**NOTICE OF ADDENDUM
ADDENDUM NO. 1**

**CONTRACT NO. 7459, PROJECT NO. 53W1772, MUNIS NO. 107814
YAHARA HILLS FACILITY IMPROVEMENTS-WINDOW REPLACEMENT**

ADDENDUM 1, ATTACHEMNT 1 CONTRACT #7459
 YAHARA HILLS FACILITY IMPROVEMENTS - WINDOW REPLACEMENT

5 BASEMENT ELECTRICAL PLAN
 II SCALE = 1/8" = 1'-0"

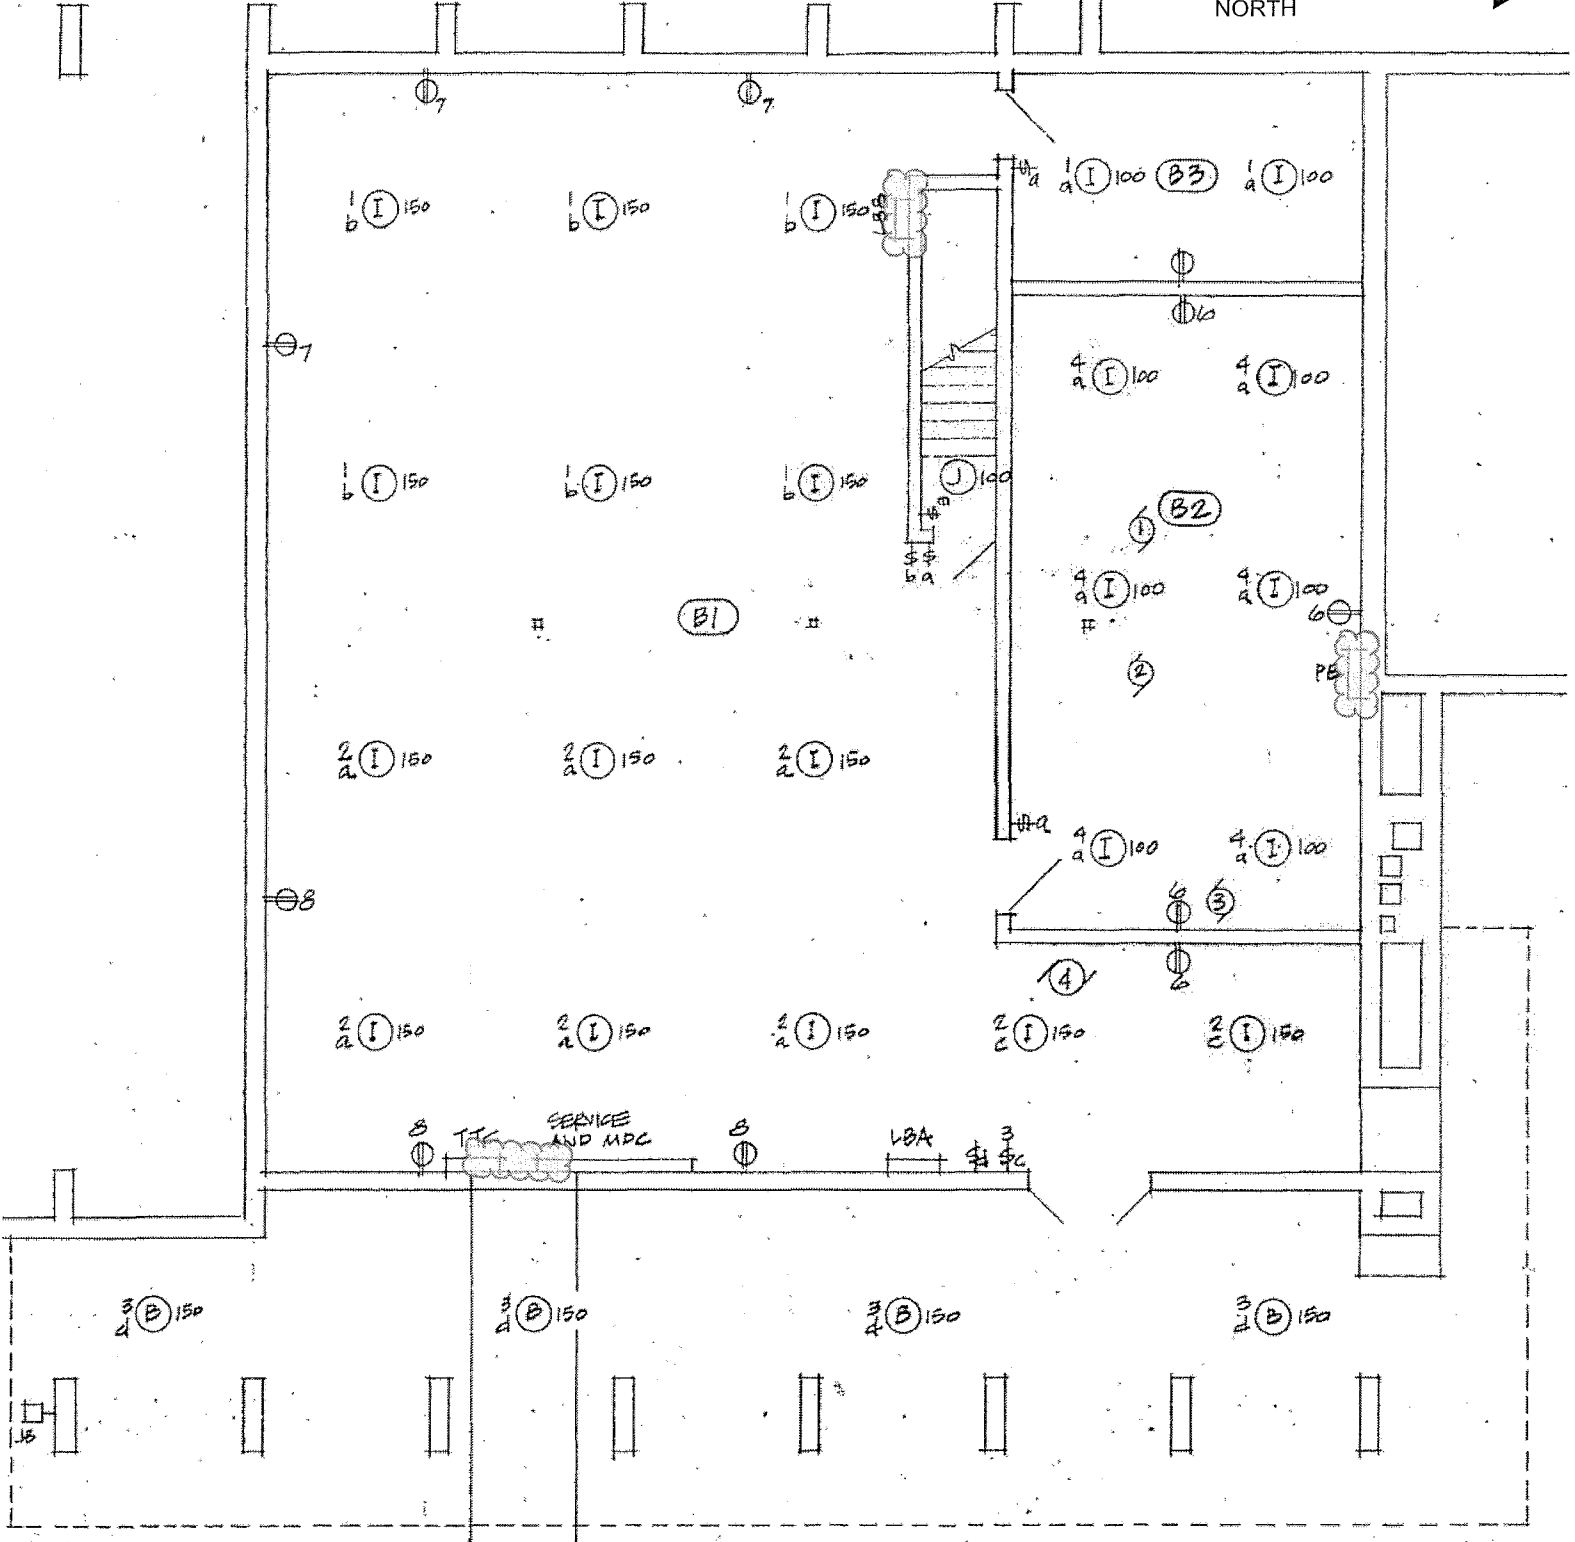
On page 2 of 25 of Division 01, SECTION 01 00 00- GENERAL REQUIREMENTS, Subsection 1.5 WORK BY THE OWNER AND OWNER FURNISHED EQUIPMENT. Paragraph B.:

Omit the sentence "The locations of this panel shall be in the electrical room on the east side of the basement." and replace it with "The location of this panel is centrally located on the north wall in the basement mechanical room. The Electrical contractor has the option to investigate and utilize open circuits in other existing panels within the basement area. See Attachment 1 for panel locations.

LOCATION OF EXISTING ELECTRICAL PANELS IN BASEMENT AREA.
 THIS DRAWING IS INTENDED TO SHOW THE LOCATION OF THE EXISTING PANELS ONLY. THIS IS THE ORIGINAL ELECTRICAL DRAWING FOR THE FACILITY AND DOES NOT REFLECT CHANGES OR MODIFICATION TO THE ELECTRICAL SYSTEM OR BUILDING.
